Final Technical Plan
July 1988

LITIGATION TECHNICAL SUPPORT AND SERVICES

Rocky Mountain Arsenal

Offpost Remedial Investigation/Feasibility Study

Figure 1.4-1
DIMP ASSESSMENT IN ALLUVIAL WELLS
FOR CONSUMPTIVE USE-PHASE I AND II AND
REVISION III-360° PROGRAMS
SOURCE: ESE, 1985c; ESE, 1986b; ESE, 1986c

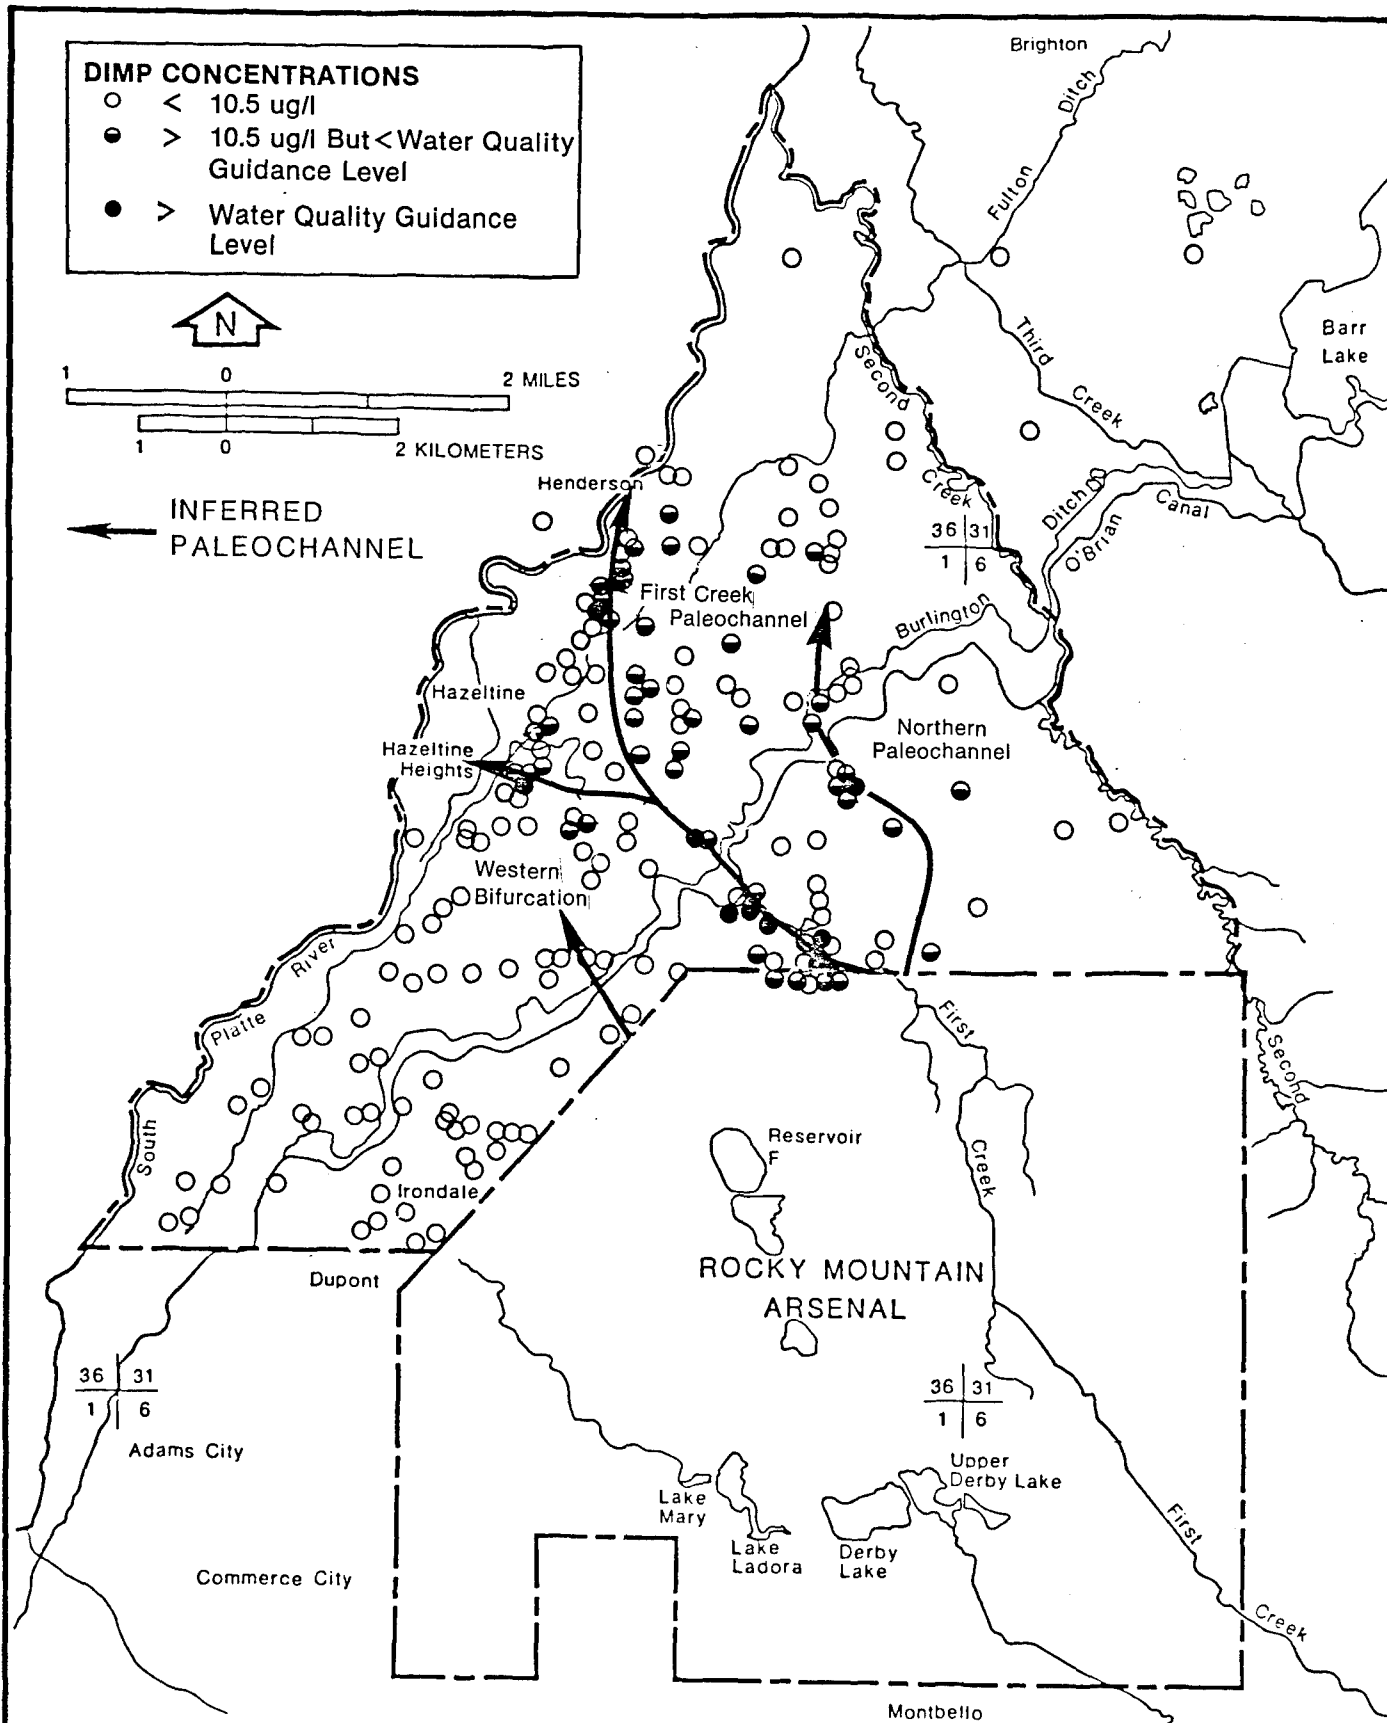
The detection limit for DIMP is listed as 10.0 ppb in the text but is listed as 11.0 ppb on Figure 1.4-1. Which is it?

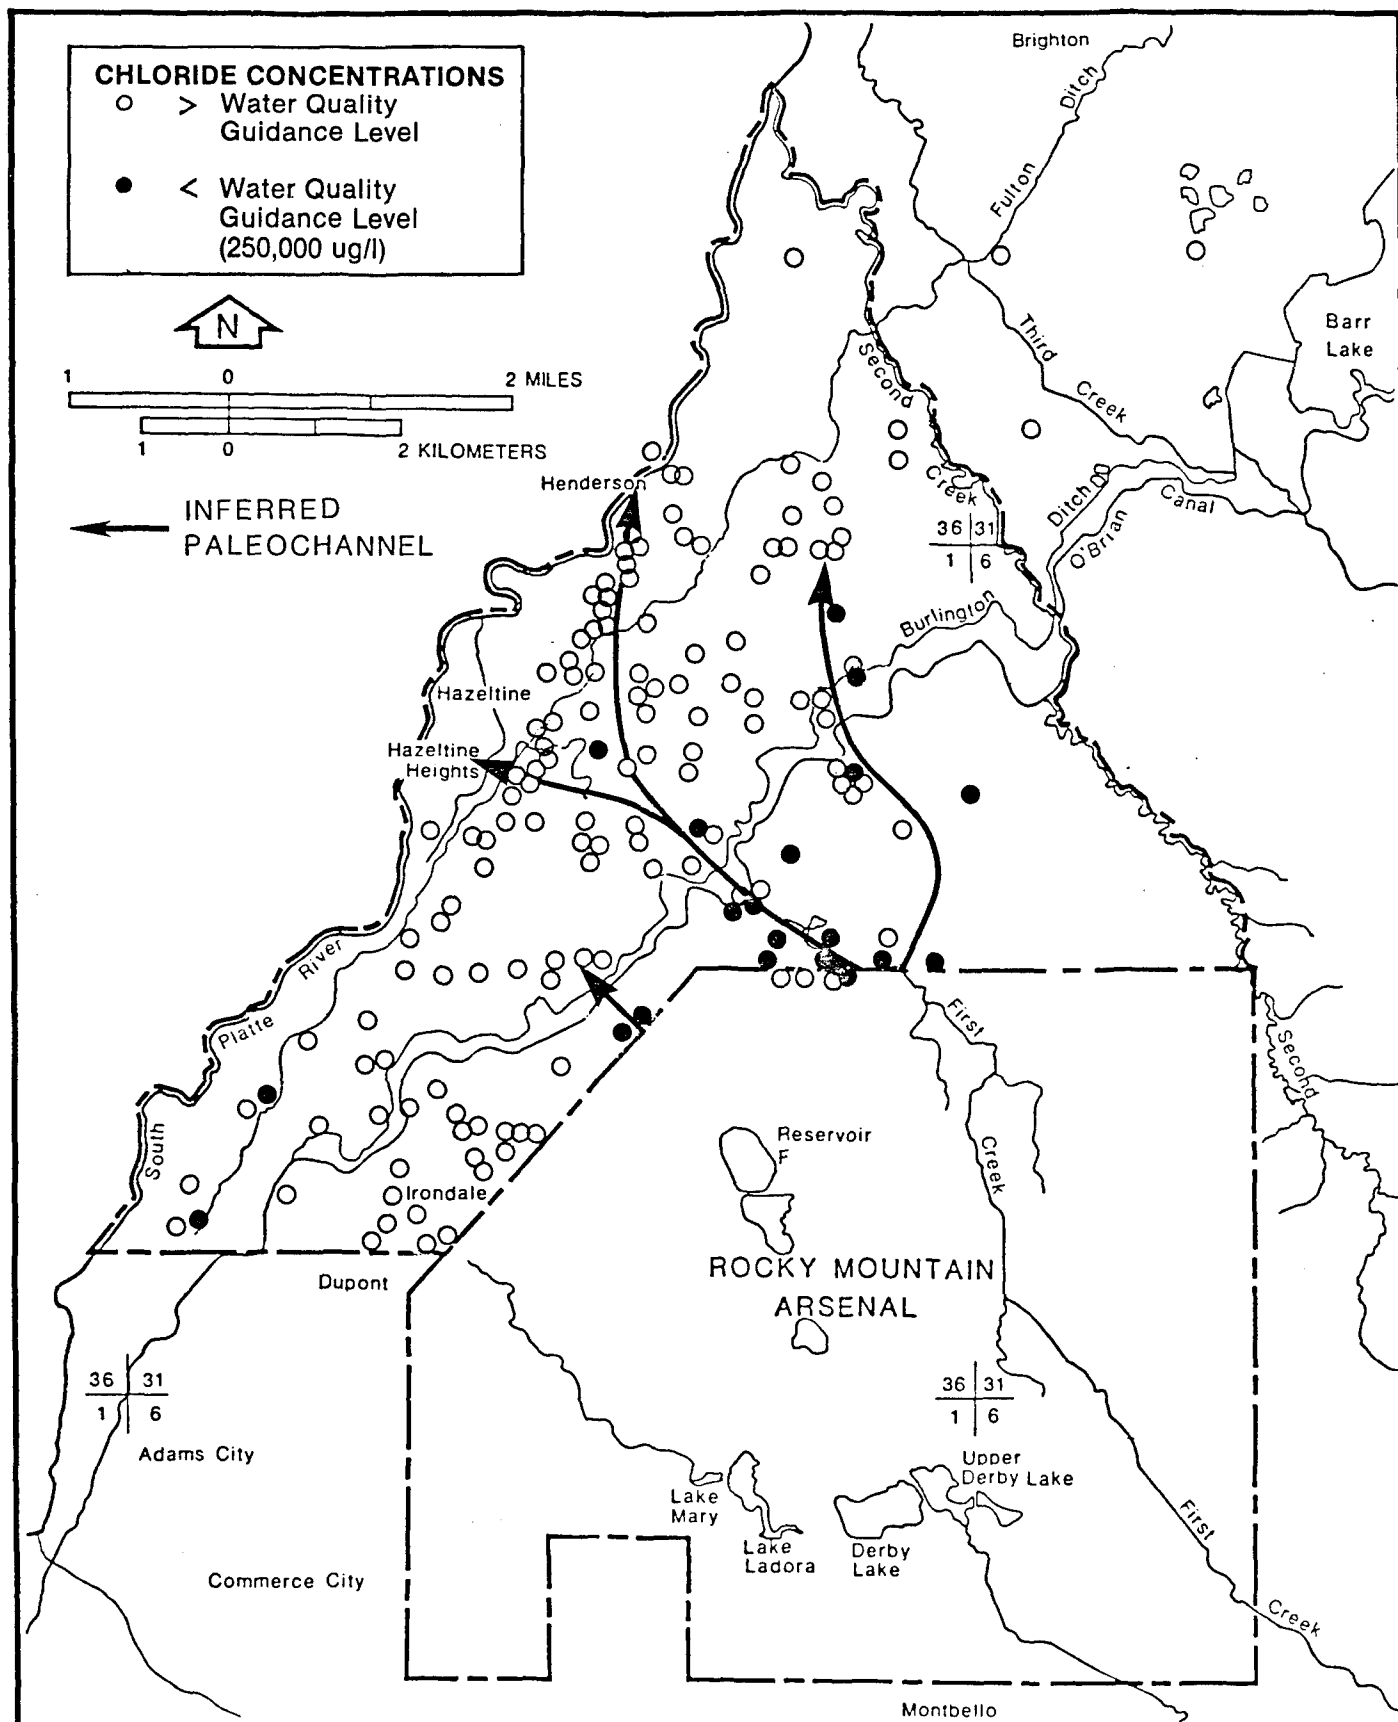
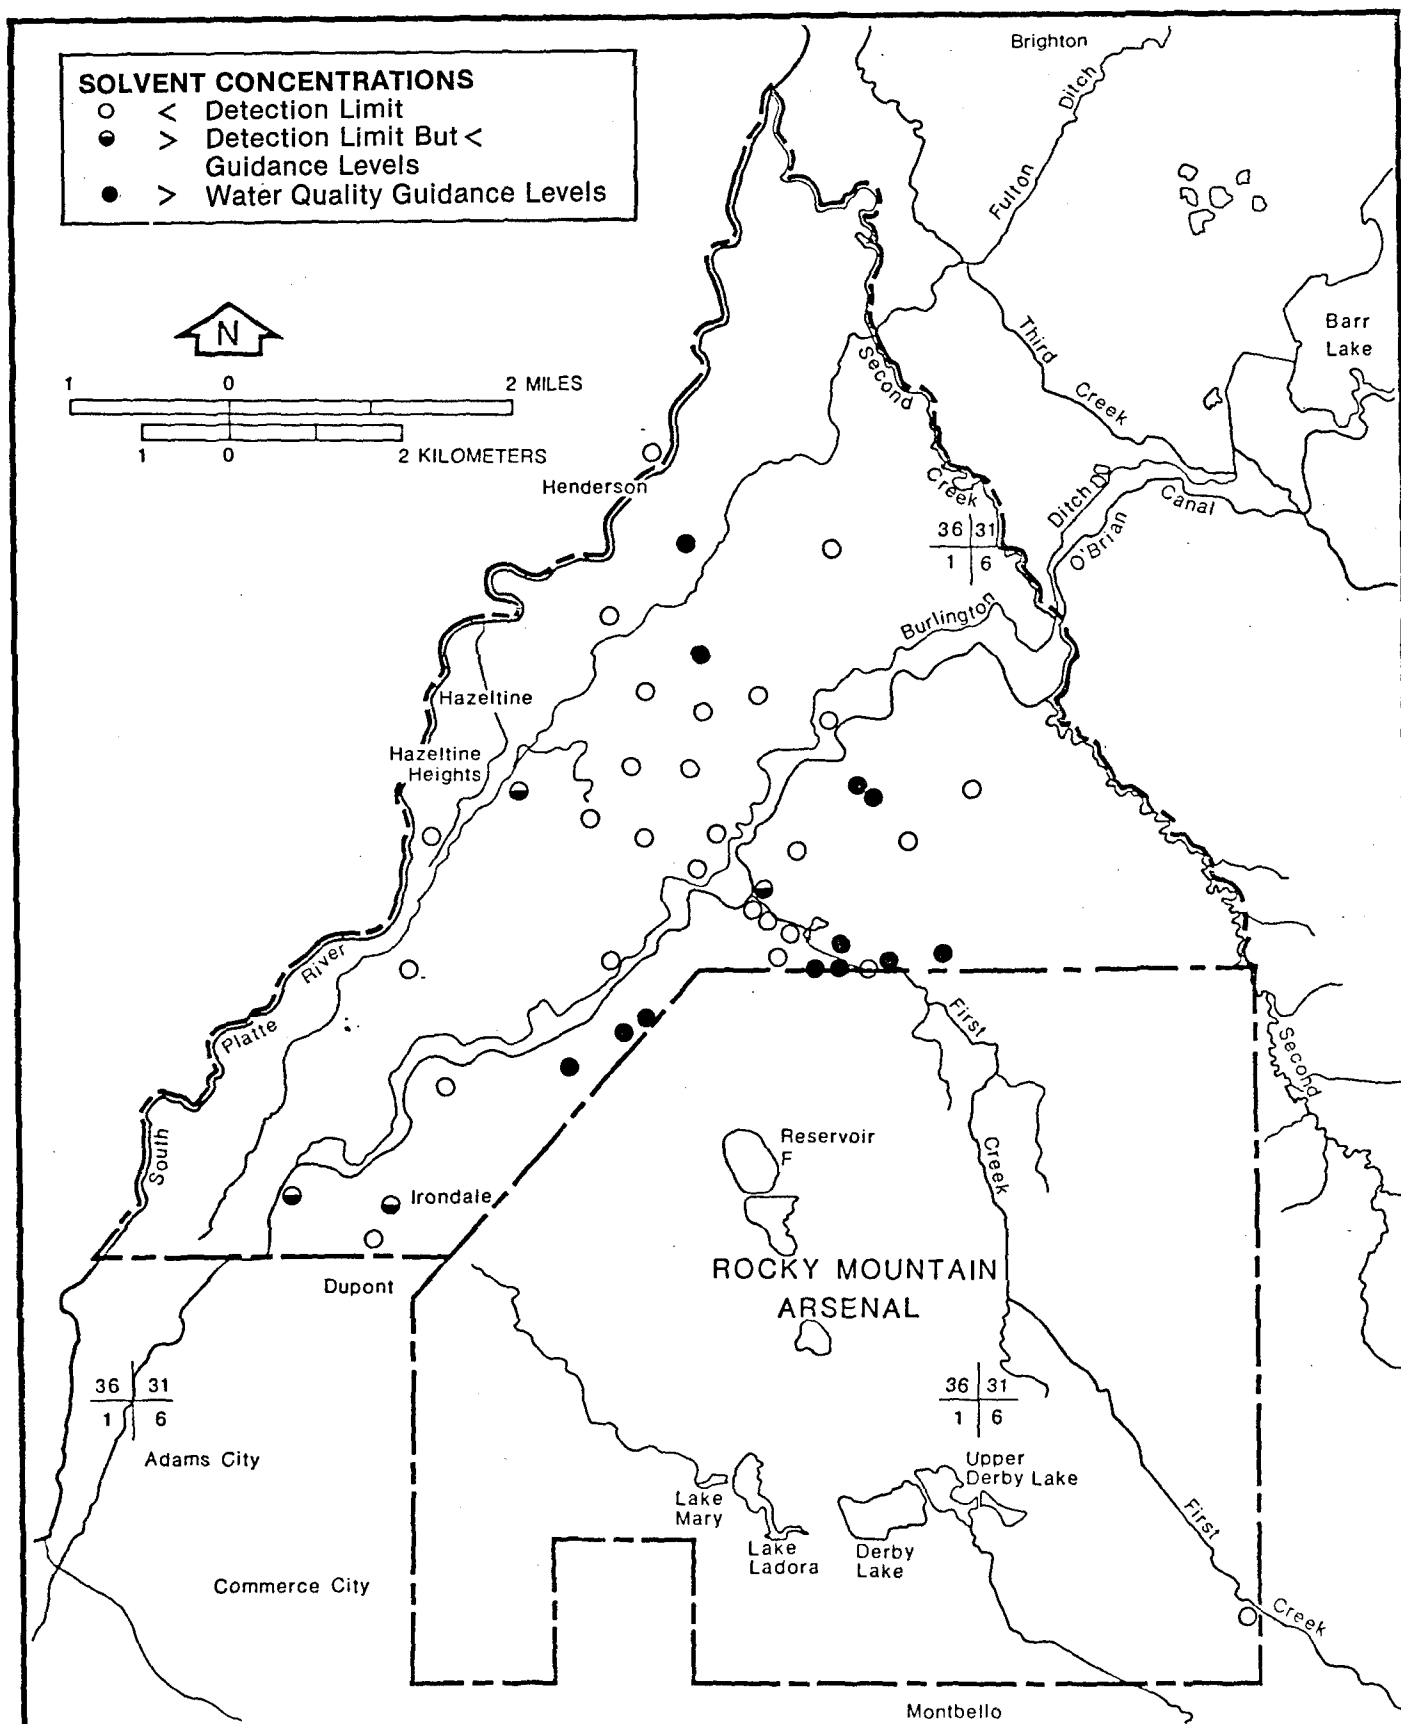
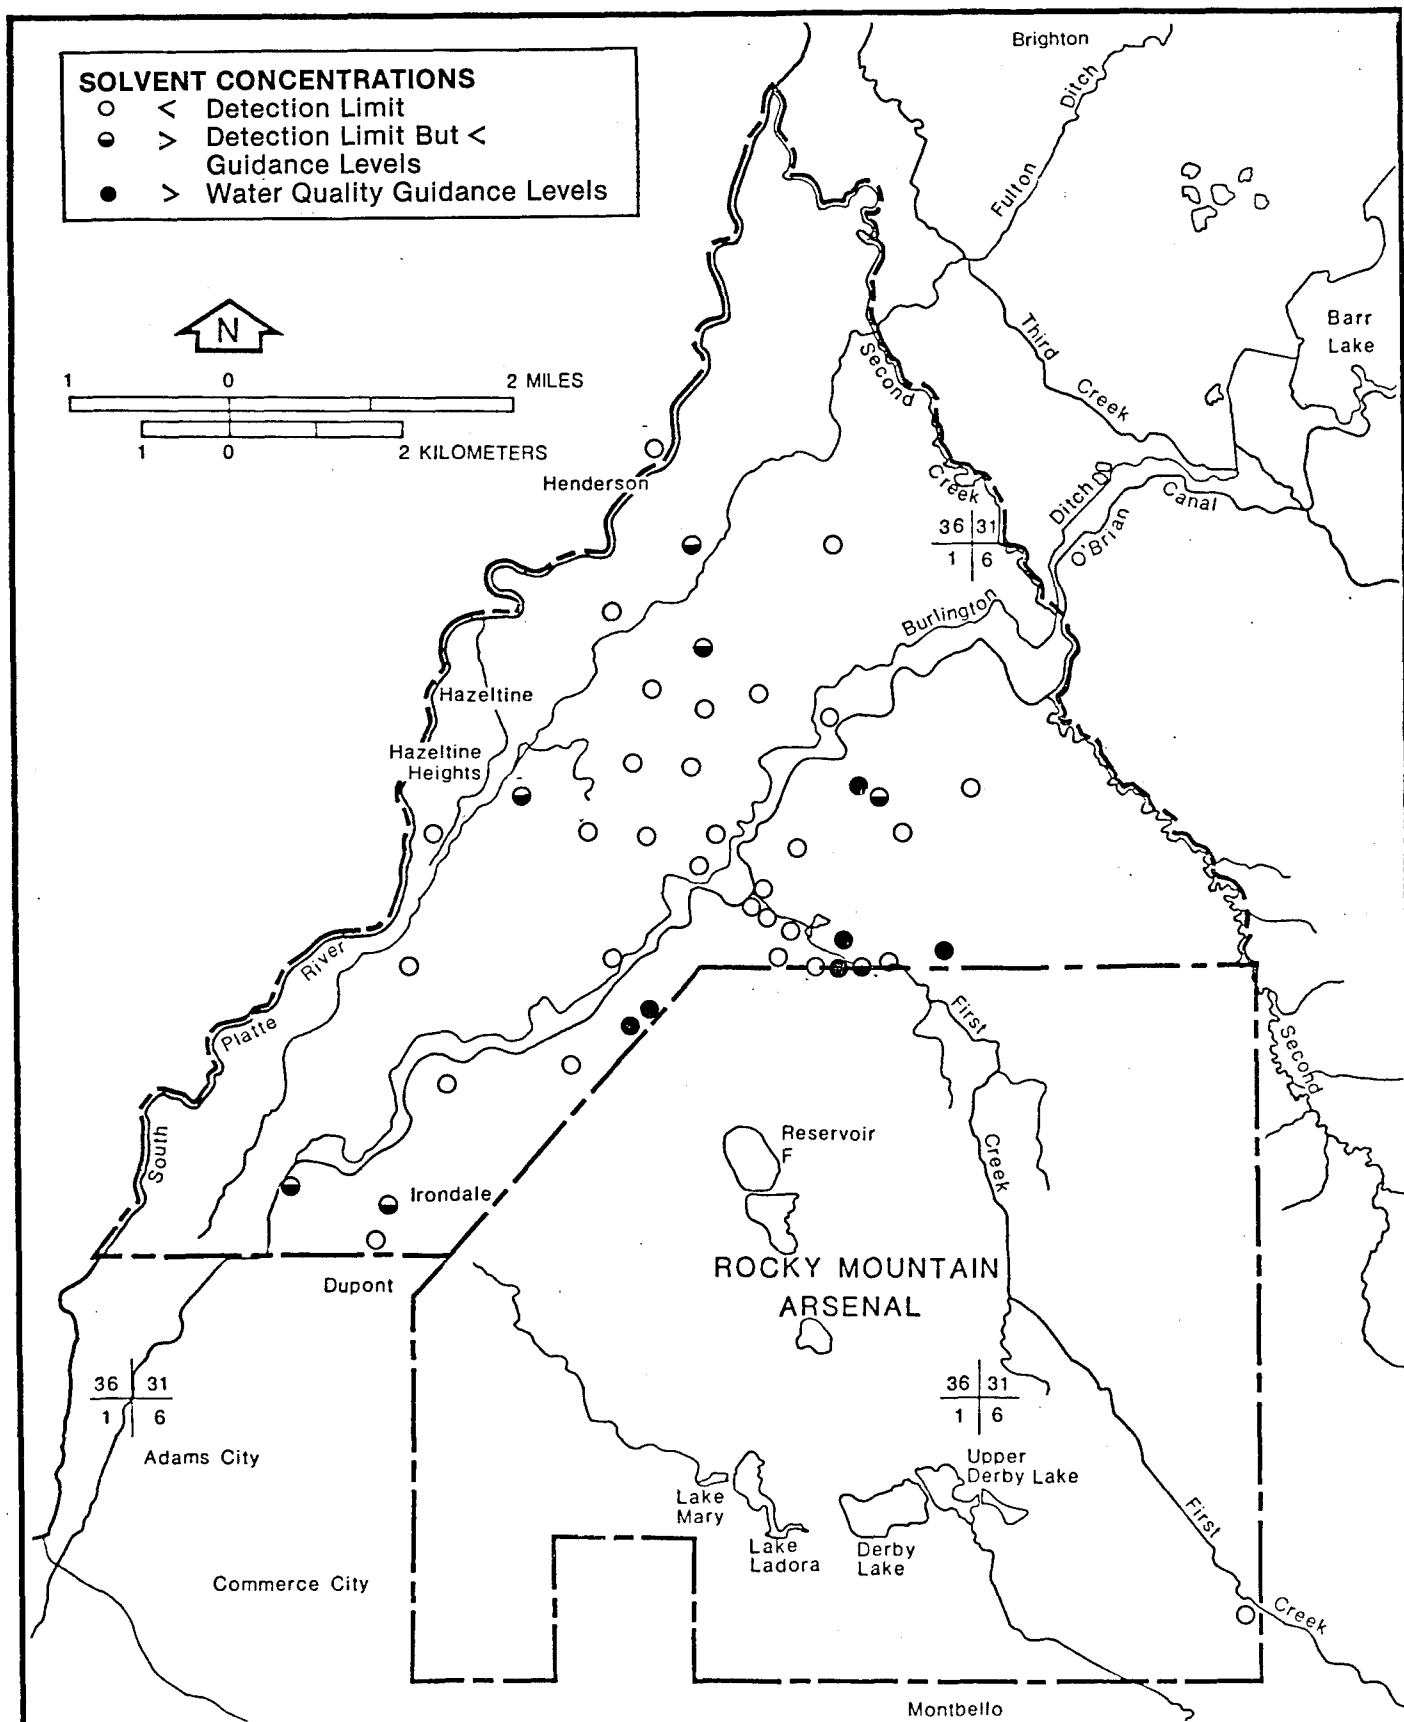
Comment 4:
Figure 1.4-1,
1.4-2, A-1 to A-9
